ADDENDUM

PROJECT:	La Vista City Centre South MU – Lot 15	**PROJECT NO.:**	F16132
TO:	Prospective Bidders	**DATE:**	05/04/2017
FROM:	BVH Architecture	**ADDENDUM NO.:**	#2

REFLECTED CEILING PLANS

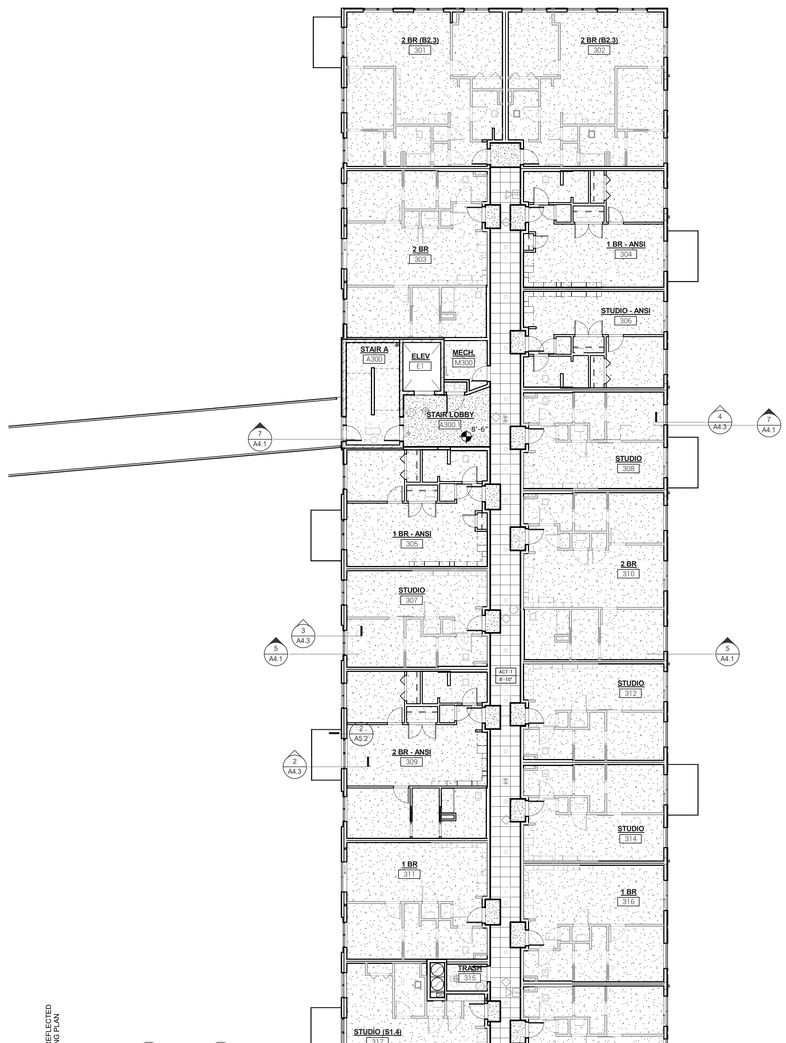
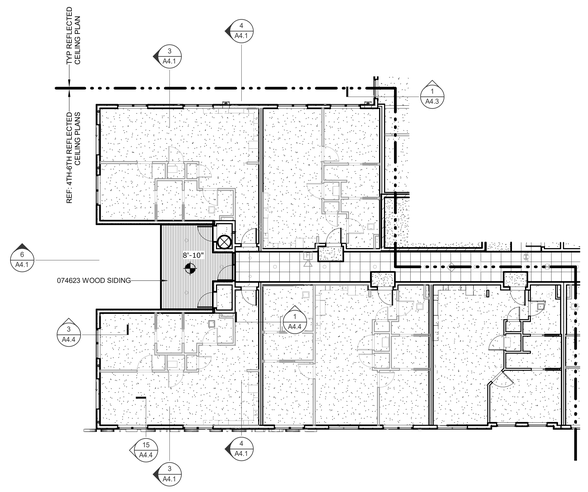
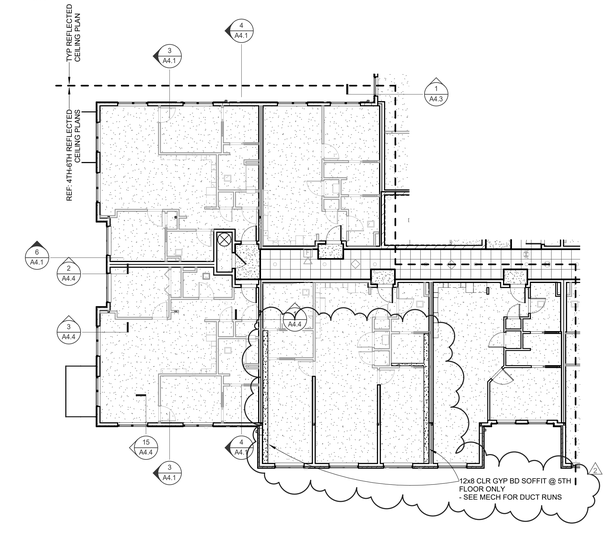
2. Sheet A8.3 Reflected Ceiling Plans:
    a. Add Soffits for Dryer and Bathroom Exhaust at Fifth Floor. Ref: Mech. Drawings.
3. Sheet S0.00:
    a. Section 1: Add Fluid Cooler Footing section

FIFTH FLOOR FRAMING PLAN

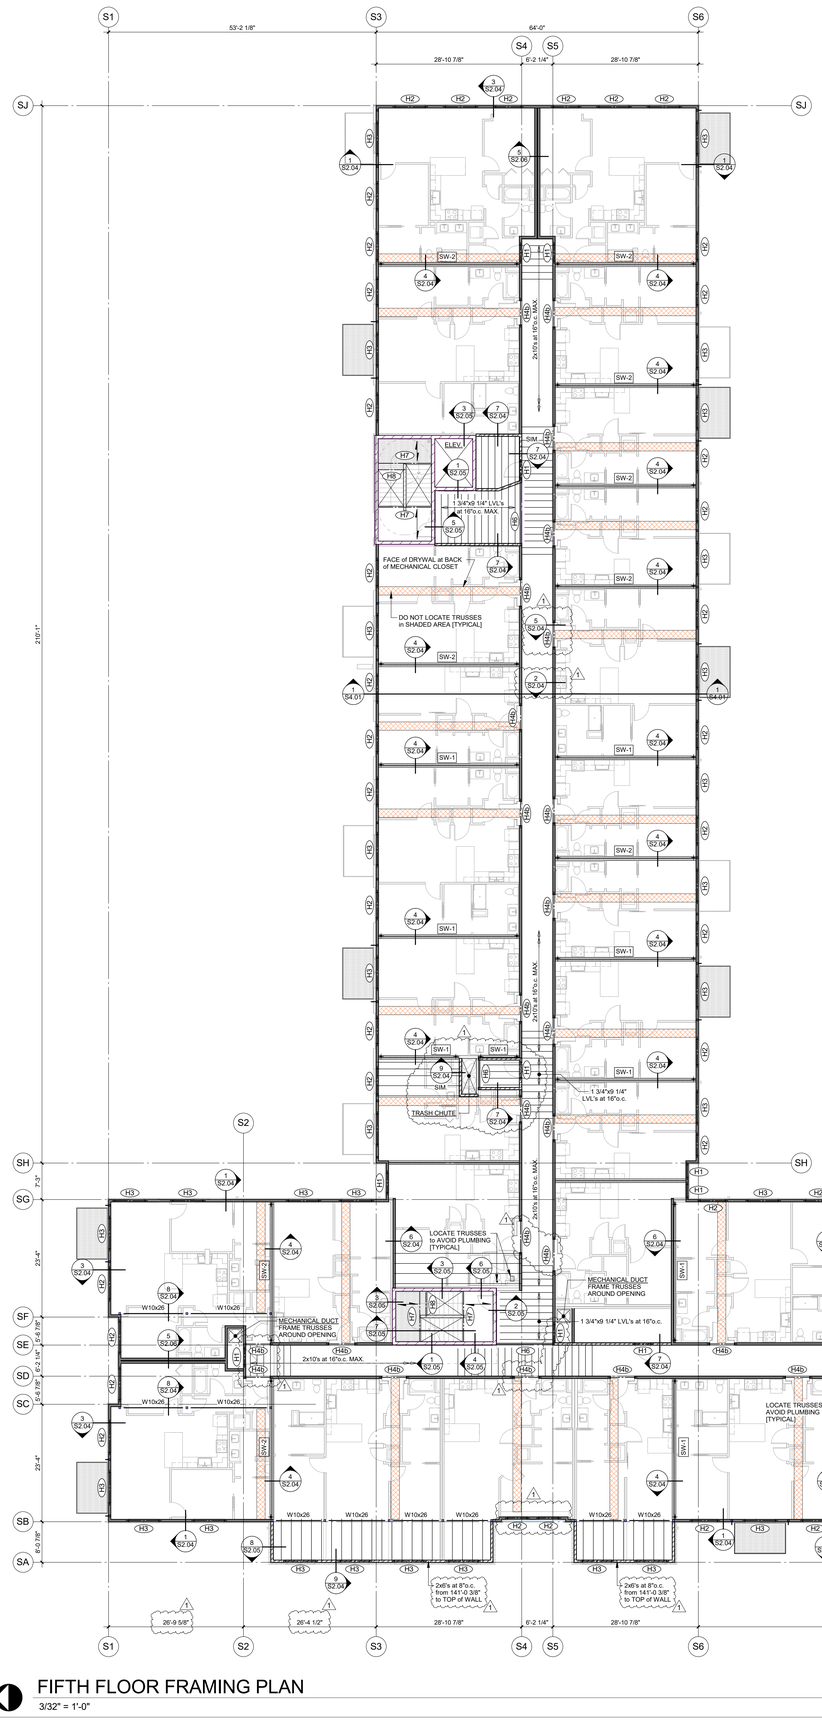
6. Sheet S2.05 – Fifth Floor Framing Plan:
    a. Revise section cut orientations along grids 'S5' and 'SE' as clouded
    b. Revise framing around Trash Chute as clouded

c. Revise headers adjacent to North-West stair as clouded
    d. Move exterior wall along grid 'SB' between grids 'S3' and 'S6' as clouded
    e. Revise header at unit entries adjacent to grid 'S2' as clouded

f. Revise exterior wall spacing from 16" to 8" at studs between grids 'SA' and 'SB'
    g. Move grid 'S2' ½" to the North as clouded
7. Sheet S2.06:
    a. Sixth Floor Framing Plan

SIXTH FLOOR PLAN
3/32" = 1'-0"

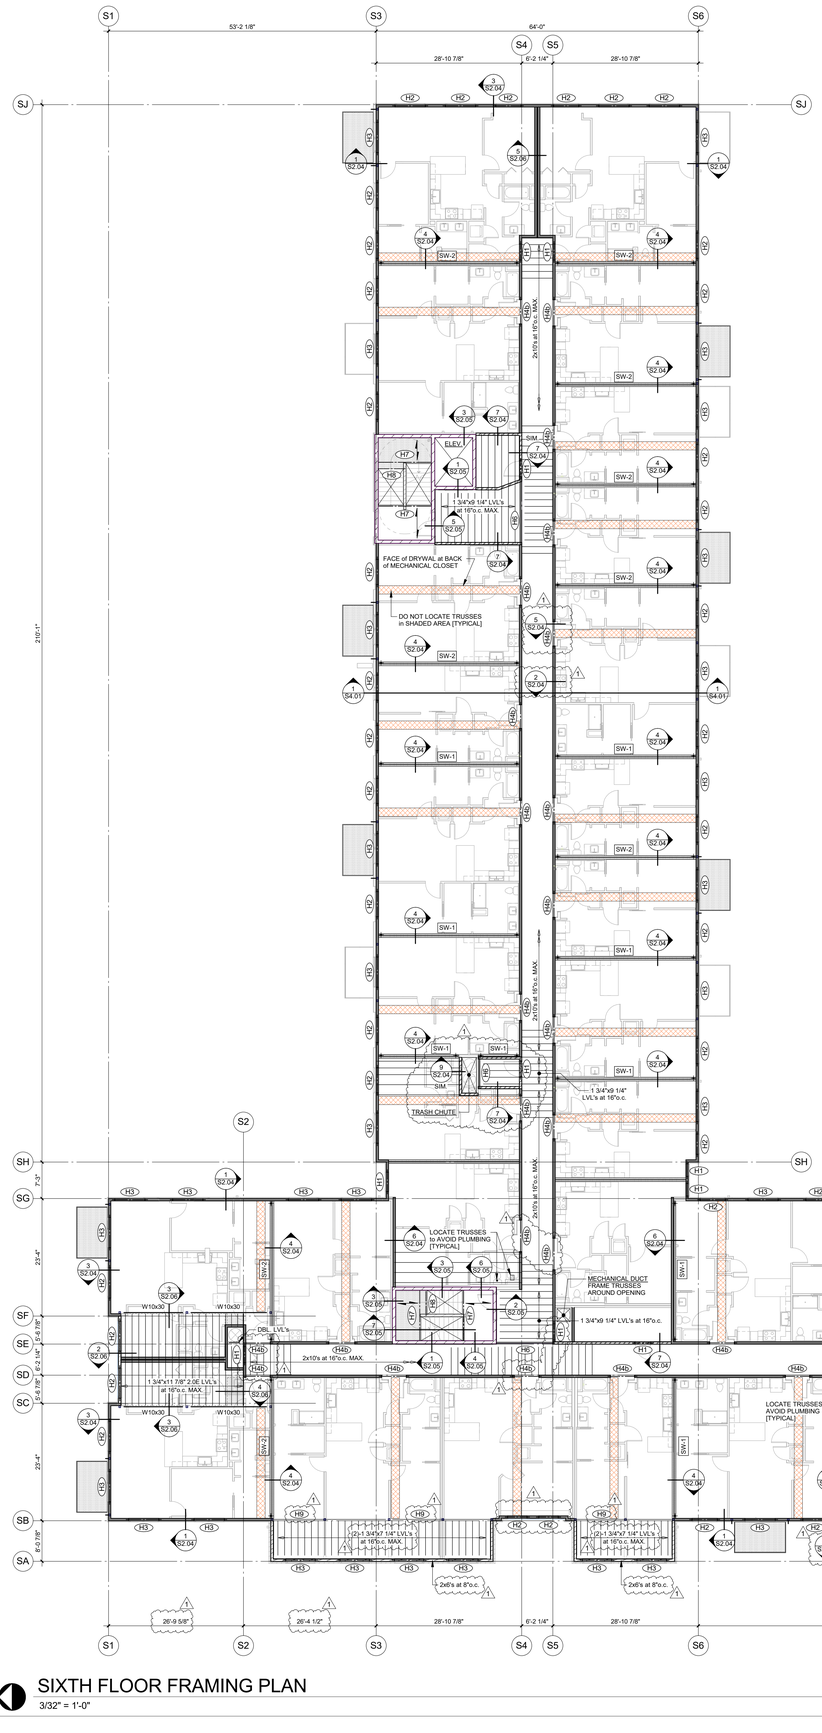
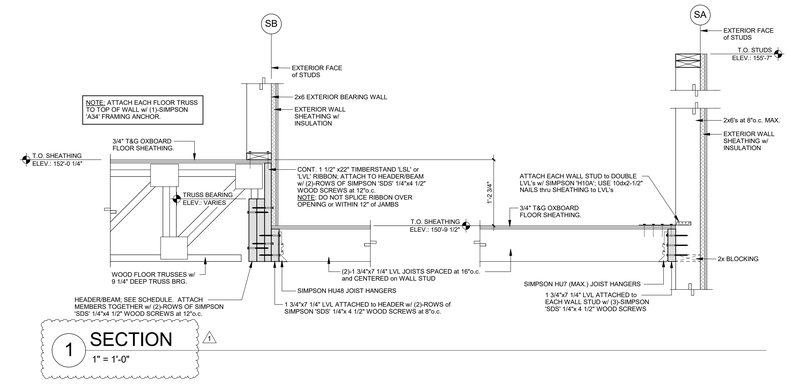
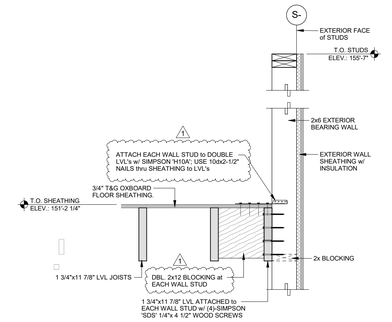
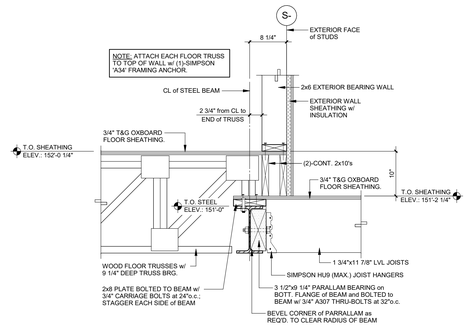
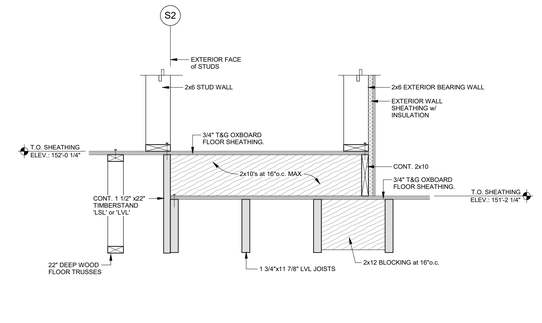
1. Revise section cut orientations along grids 'S5' and 'SE' as clouded
        2. Revise framing around Trash Chute as clouded
        3. Revise headers adjacent to North-West stair as clouded

4. Move exterior wall along grid 'SB' between grids 'S3' and 'S6' as clouded
        5. Revise header at unit entries adjacent to grid 'S2' as clouded

6. Revise exterior wall spacing from 16" to 8" at studs between grids 'SA' and 'SB'

7. Move grid ‘S2’ ½” to the North as clouded
8. Revise W10 steel beams along grid ‘SB’ to wood beam/header ‘H9’ as clouded
9. Revise floor joists between grids ‘SA’ and ‘SB’ as clouded

b. Sections
1. Section 1: Revise in its entirety as clouded
2. Section 2: Revise/Add notes as clouded
3. Section 6: Add Section

ROOF FRAMING PLAN
3/32" = 1'-0"

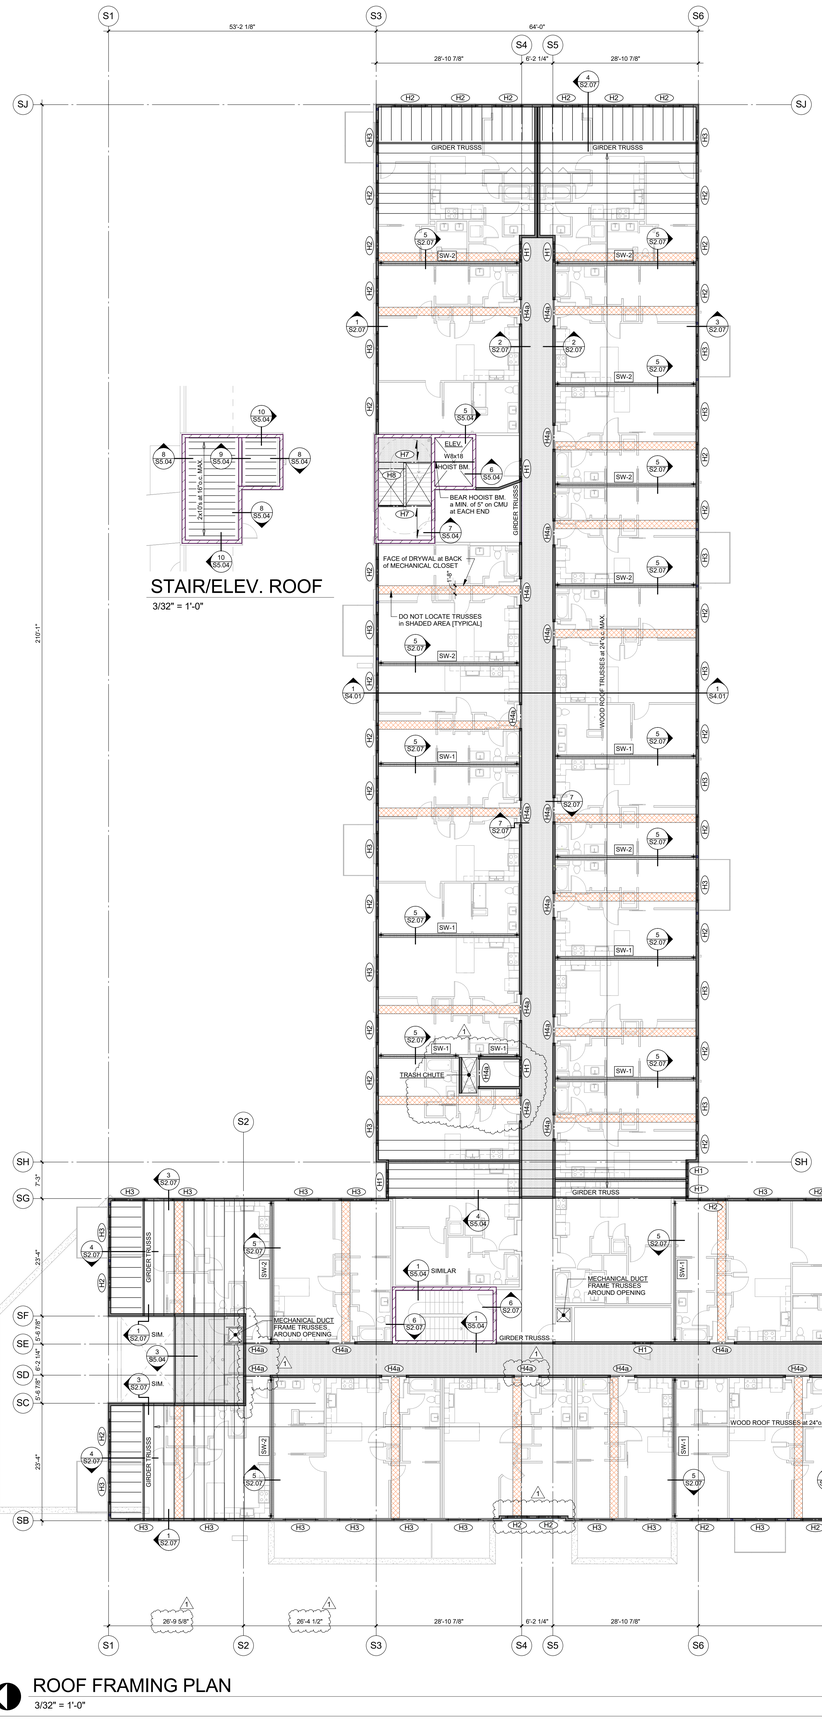
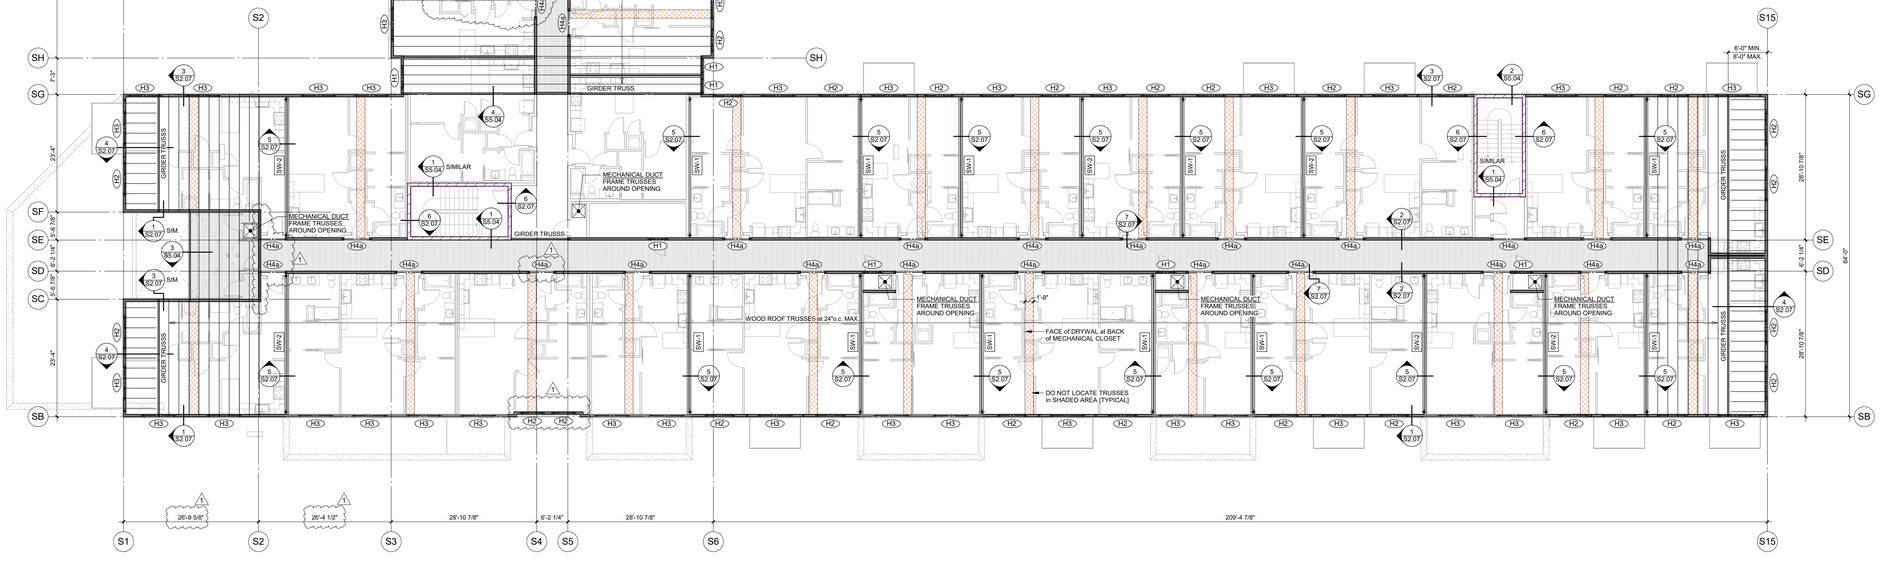
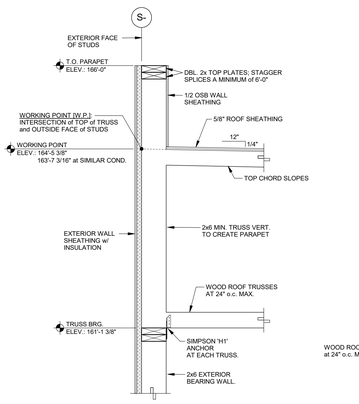
8. Sheet S2.07 – Roof Floor Framing Plan:
   a. Revise framing around Trash Chute as clouded
   b. Revise headers adjacent to North-West stair as clouded
   c. Move exterior wall along grid ‘SB’ between grids ‘S3’ and ‘S6’ as clouded
   d. Revise header and wall framing at unit entries adjacent to grid ‘S2’ as clouded
   e. Move grid ‘S2’ ½” to the North as clouded
9. Sheet S4.01 – Header Schedule:
   a. Add Header type ‘H9’ as clouded
10. Reference Mechanical and Electrical Addendum #2.

1 00-GROUND FLOOR - UNDERGROUND - PLUMBING

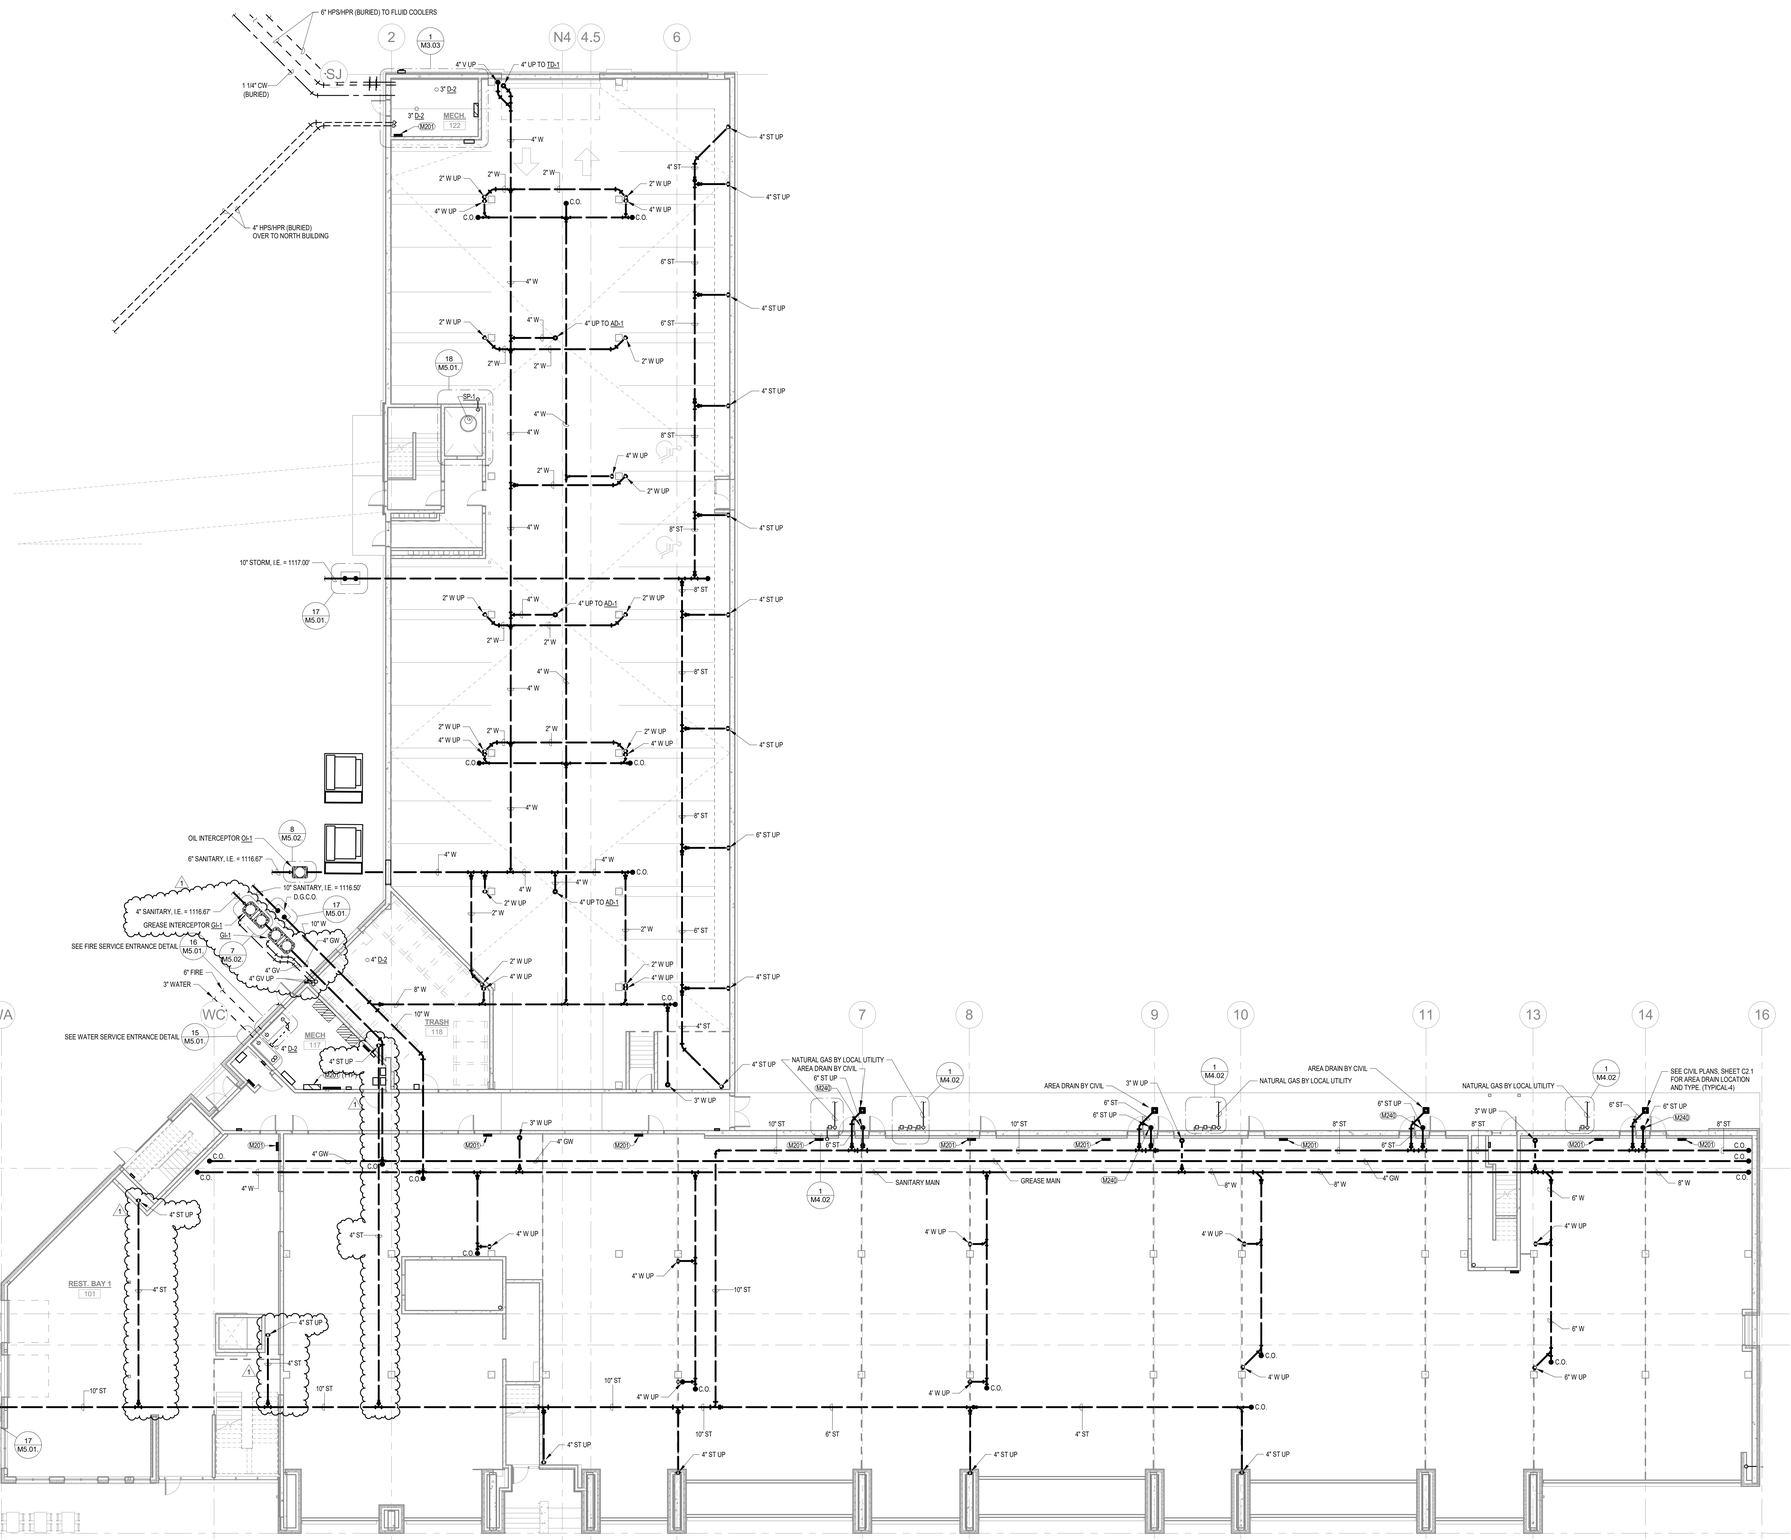
5. Sheet M2.00 – UNDERGROUND PLAN – PLUMBING
    a. See plan revisions.
6. Sheet M2.01 – GROUND FLOOR – Plumbing
    a. See plan revisions.
7. Sheet M2.02 – Second Floor – Plumbing
